Docket Item # 15  
DEVELOPMENT SPECIAL USE PERMIT #2001-0026  
ROCKY GORGE - CAMERON STATION (Phase III)

Planning Commission Meeting  
April 2, 2002

**ISSUE:** Consideration of a request for a development special use permit amendment to enlarge building footprint for building # 4 of the Phase III site plan.

**LOCATION:** 5010 Duke Street  
Cameron Station, Phase III

# Attachment No.1

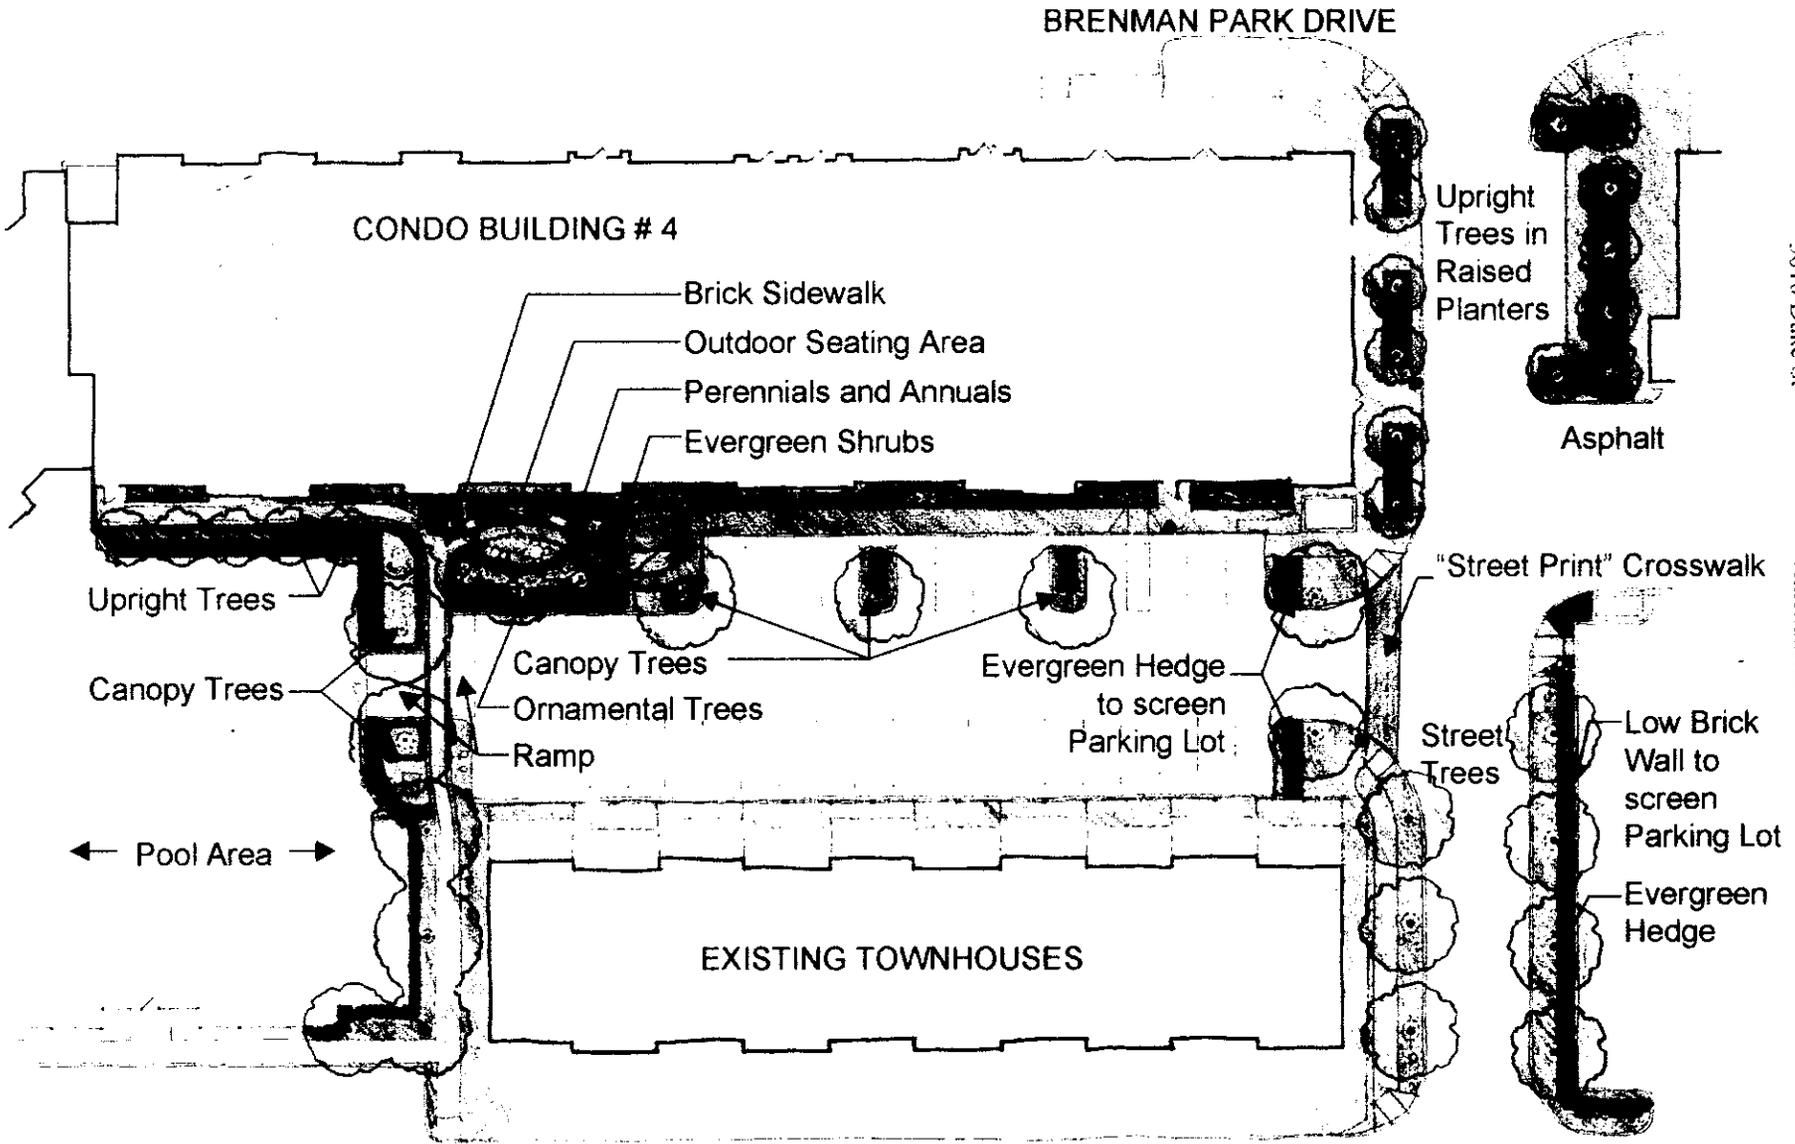
69. (NEW CONDITION) The applicant shall provide additional open space, landscape islands, outdoor seating and other amenities as generally depicted in Attachment No.1, to the satisfaction of the Director of P&Z. The level of amenities and landscaping shall not be decreased below that depicted on Attachment No.1 including:

- d. An evergreen screening hedge to screen the surface parking lot and a minimum of two landscape islands.
  - e. Relocation of the sidewalk adjacent lot #207 to provide a landscape strip and street trees adjacent to the street.

- f. Trees surrounding the perimeter of the pool.
  - g. A continuous raised planter for the southern portion of the building.
  - h. A 3.5 ft. decorative brick wall to screen the surface parking adjacent to building #3.

- i. Dense evergreen planting to screen the existing transformer. (P&Z)
70. (NEW CONDITION) The applicant shall revise the site plan, landscape plan and architectural elevations to reflect the conditions of the major amendment. The revised plans shall be approved by the Departments of Planning & Zoning and Transportation & Environmental Services prior to submission of a building permit. (P&Z)
